Final Environmental Impact Report

231 Grant Educator Workforce Housing

December 2021

EXISTING TREE REMOVALS

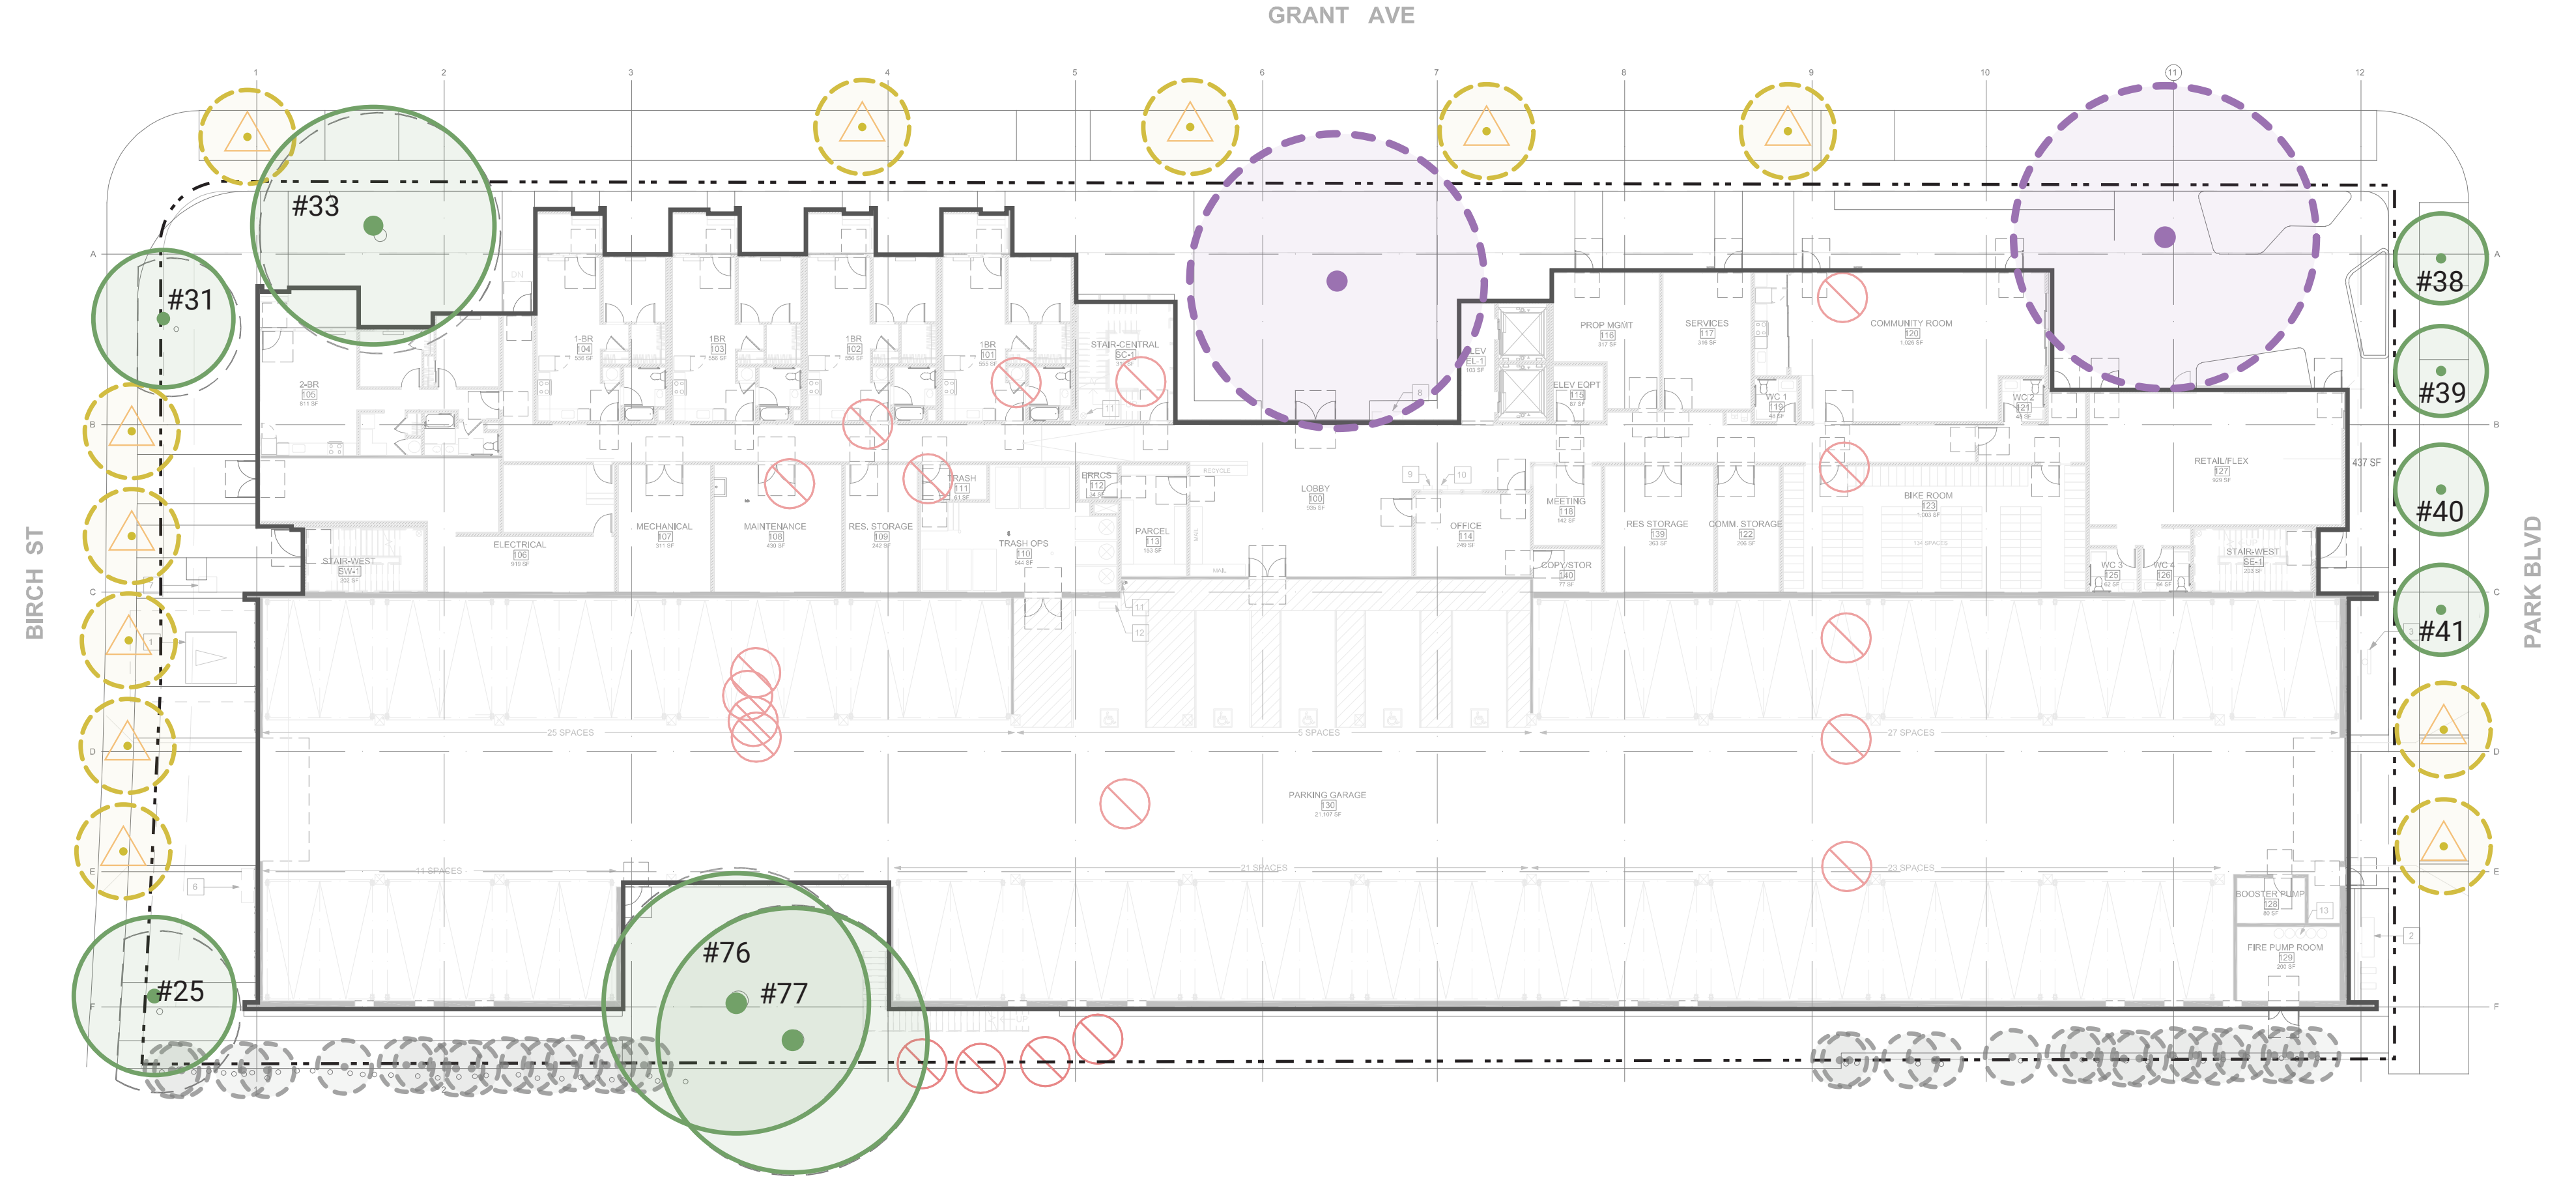
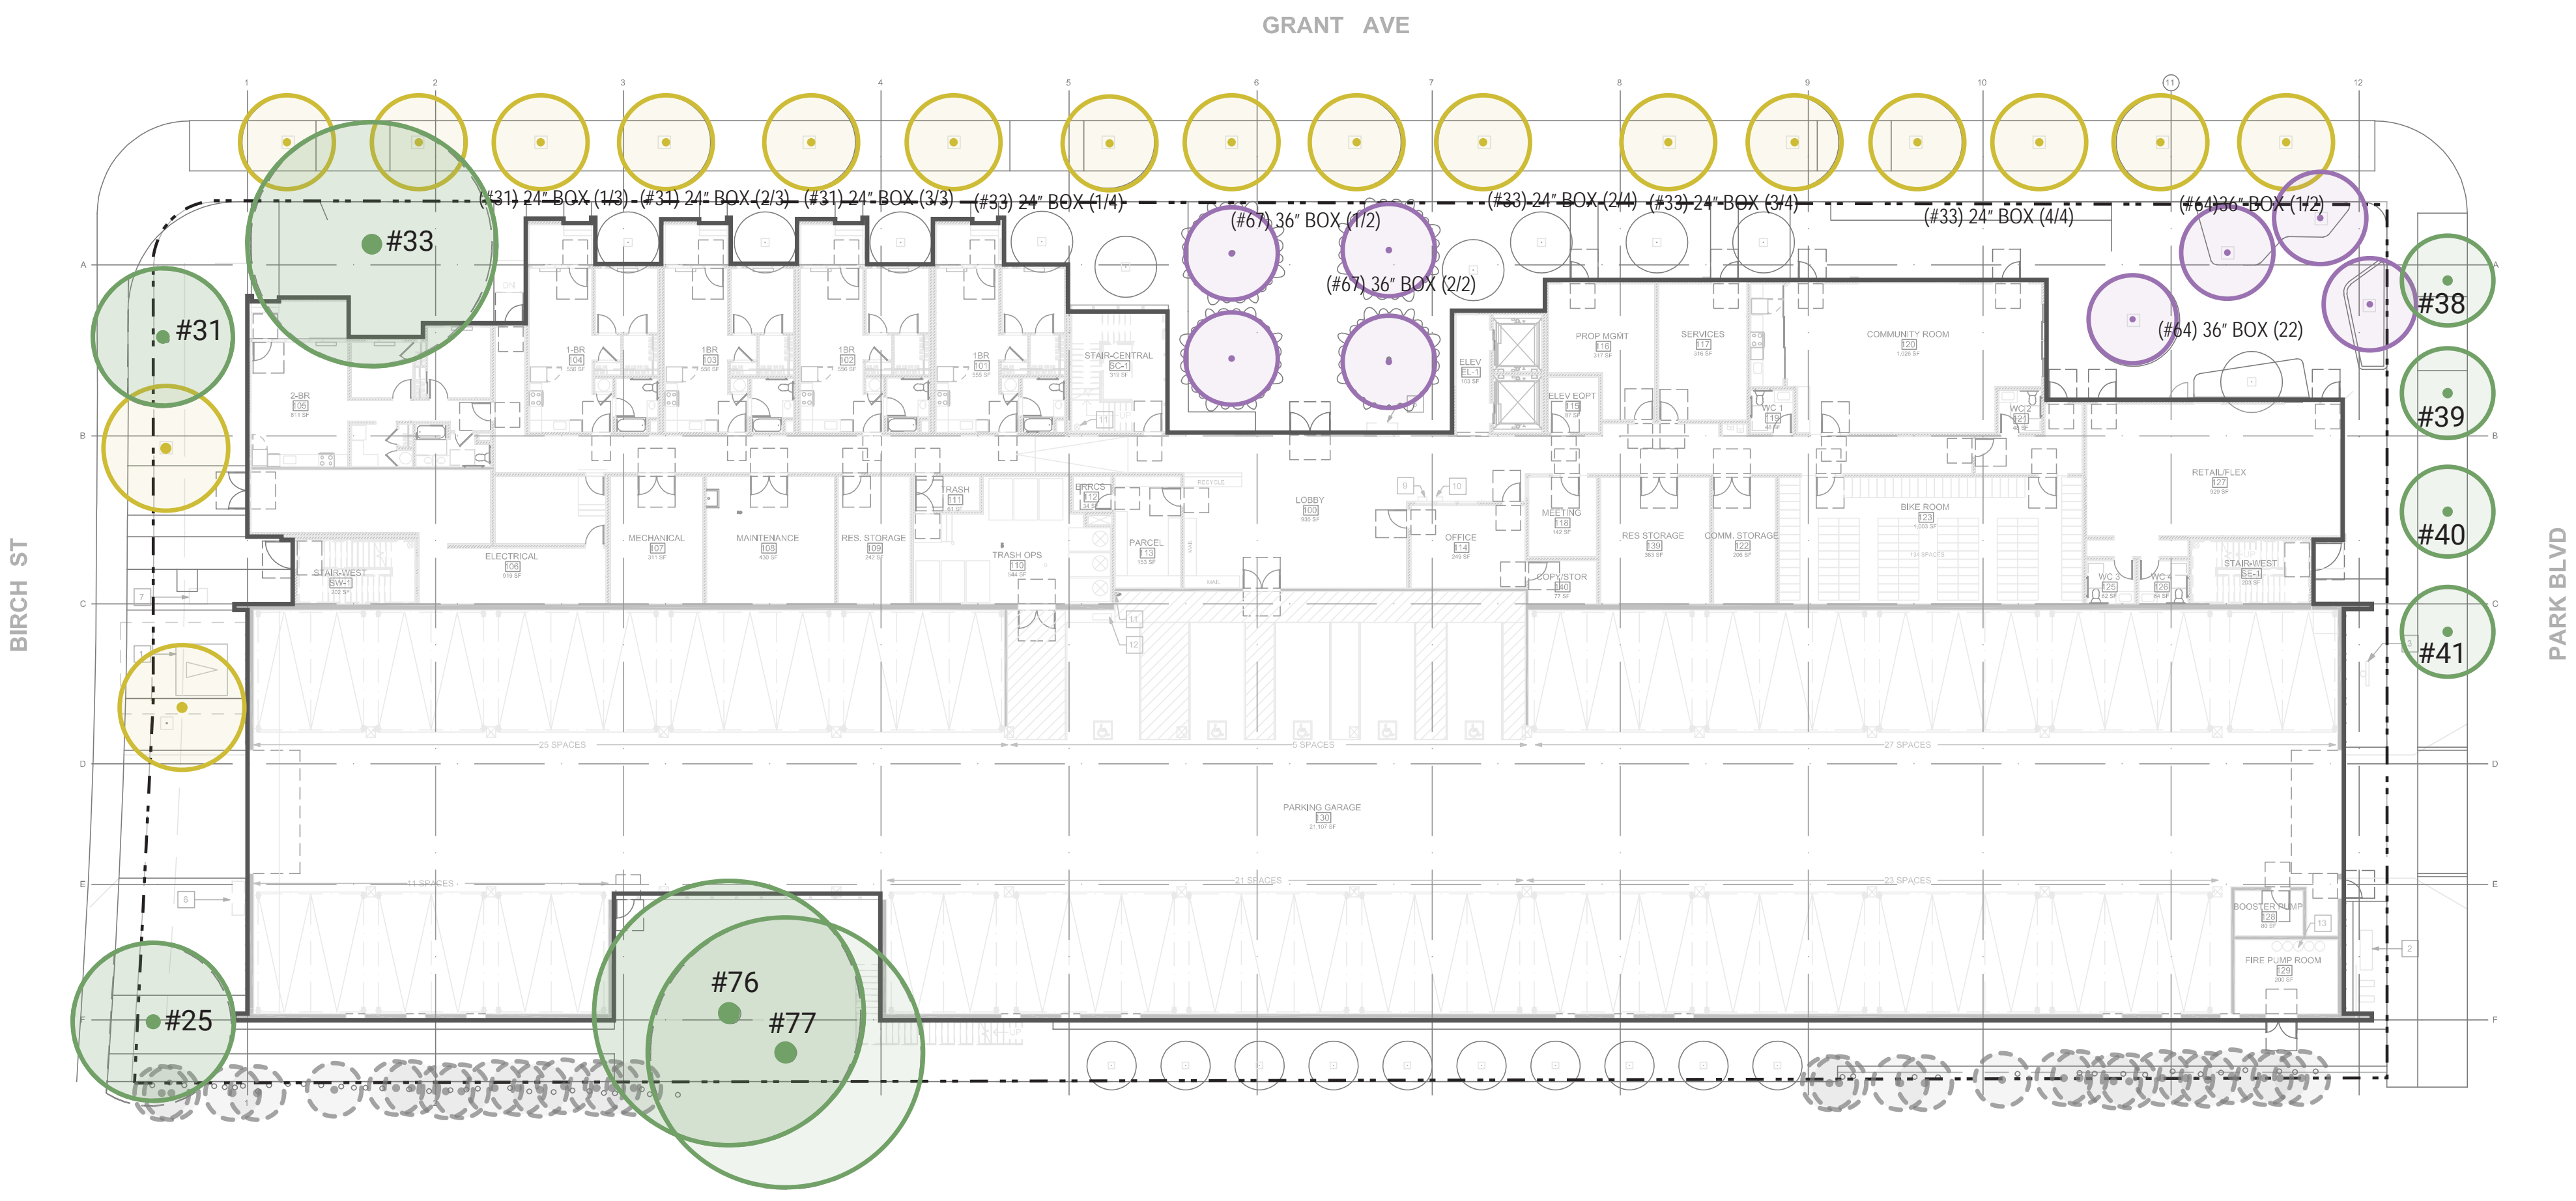
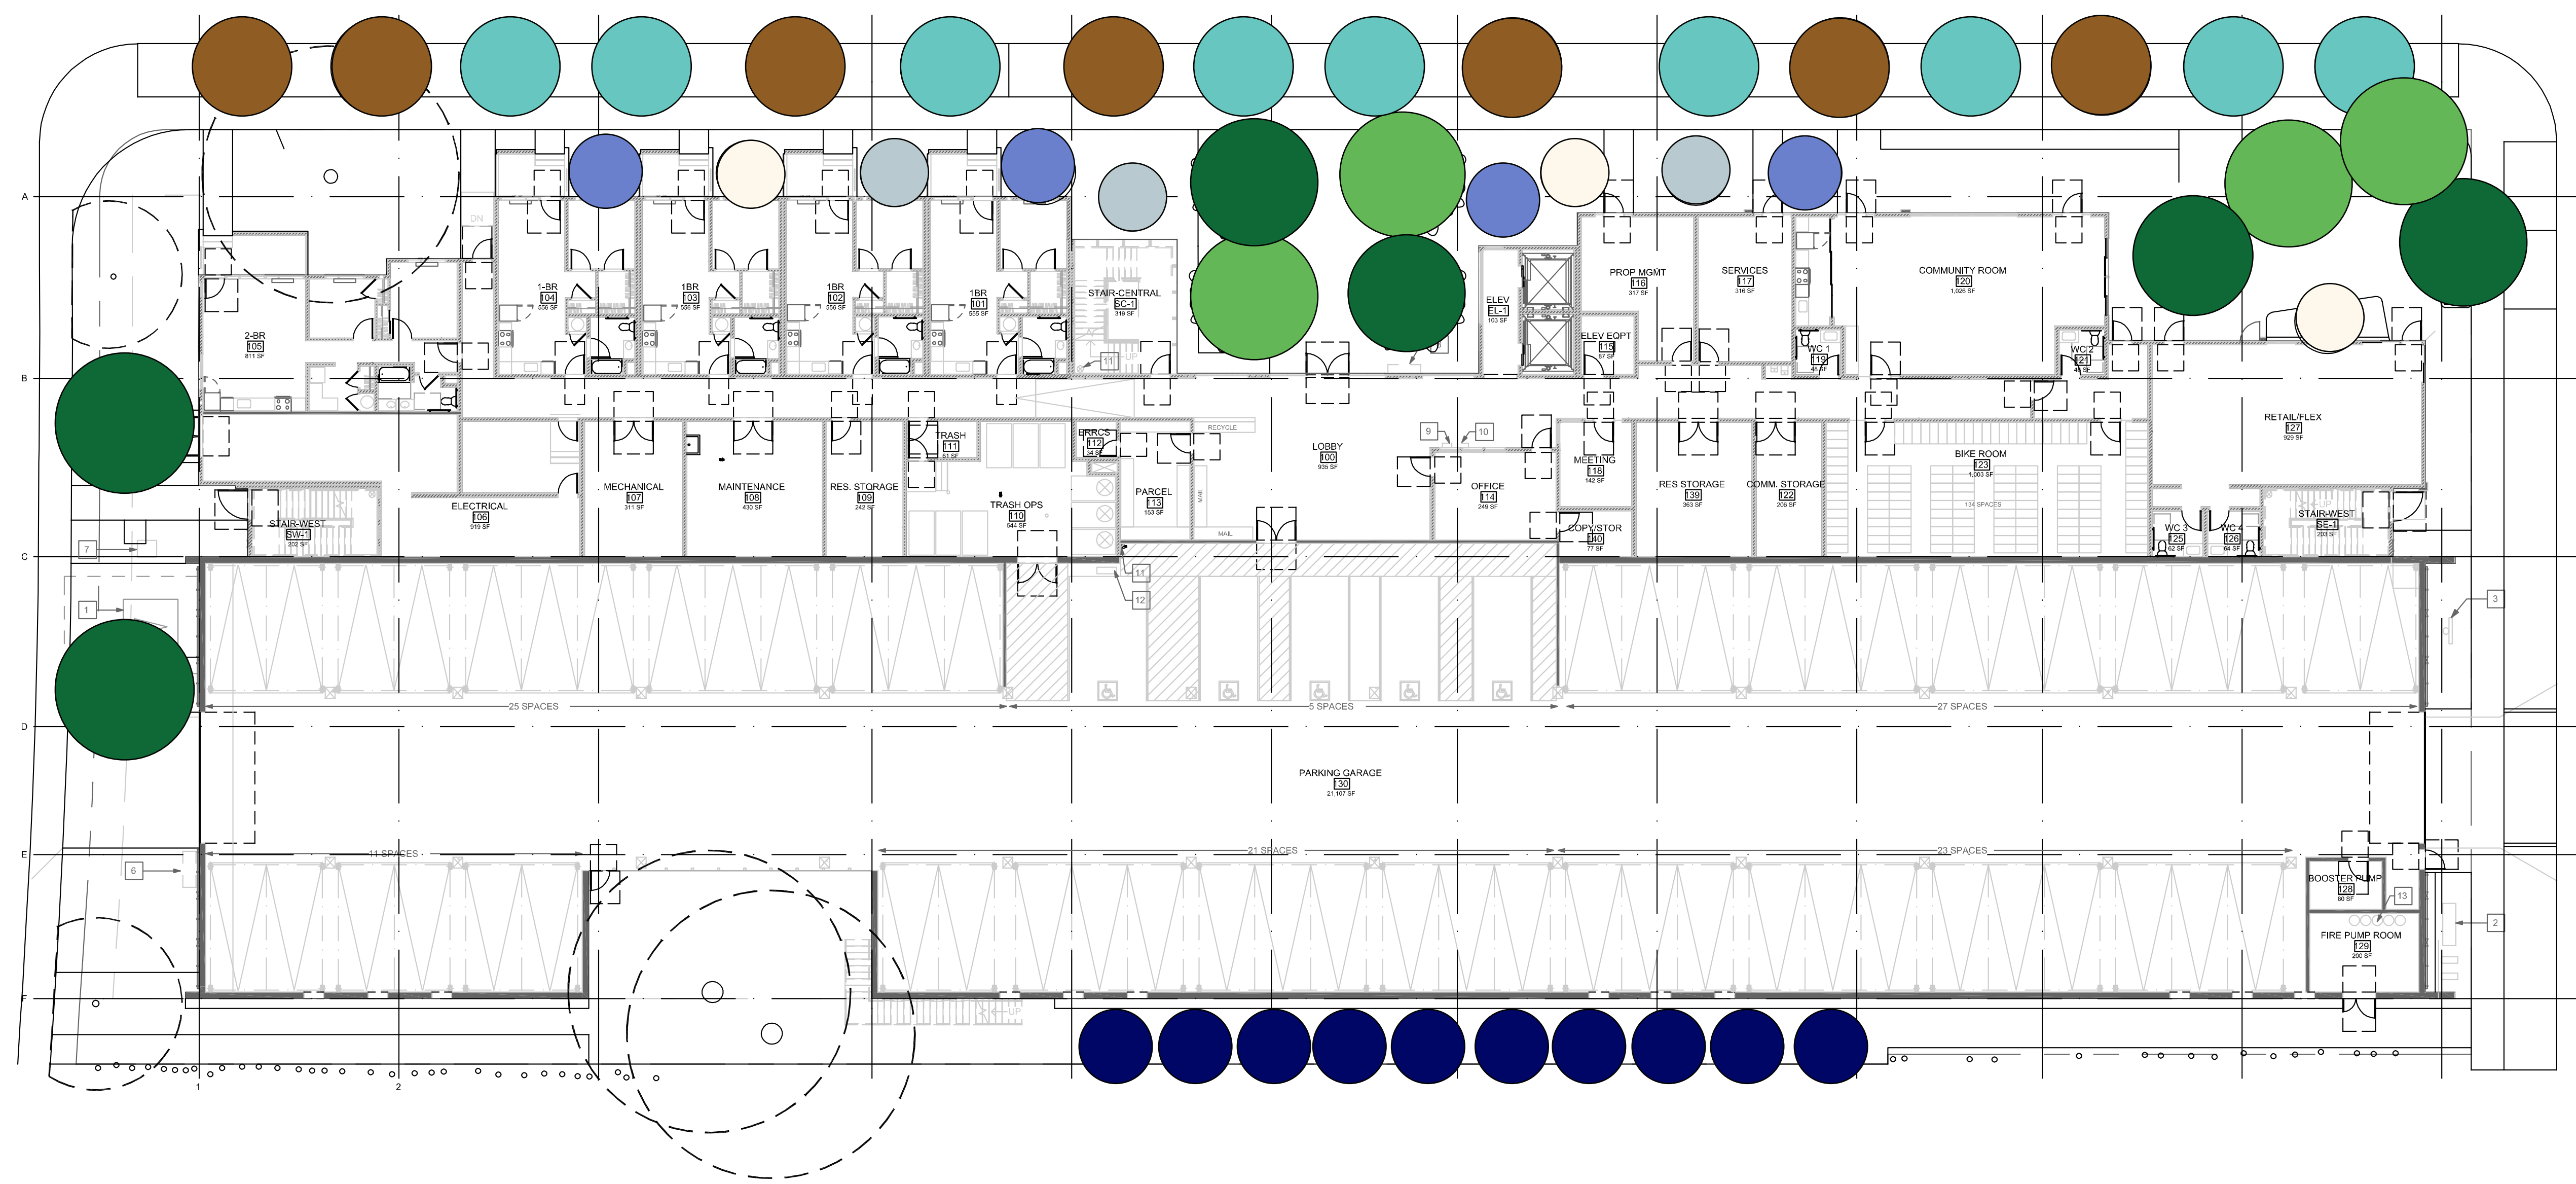
2.3.4 – Landscaping, Utilities, and Other Site Improvements – the original plans for this project called for mature trees to be preserved. Now you plan to remove more than half of the trees on the site, including two mature trees (#64 and #67) in violation of the County’s own Tree Protection Ordinance

Questions: Why is it necessary to remove ALL OF THE STREET TREES near the project? What sort of trees will replace these? Will you plant mature trees that will match the size of those being removed? Please state exactly which types of trees will be planted as replacements, how large they will be initially and their anticipated growth within the first year.

The Arborist's Report also includes tree removal and replacement plans (Sheets L3.00 and L3.10) showing the proposed size and species of replacement plantings, although these details may change in order to meet any conditions of the City's permit for city trees or County approval process. Proposed species recommended for replanting include:
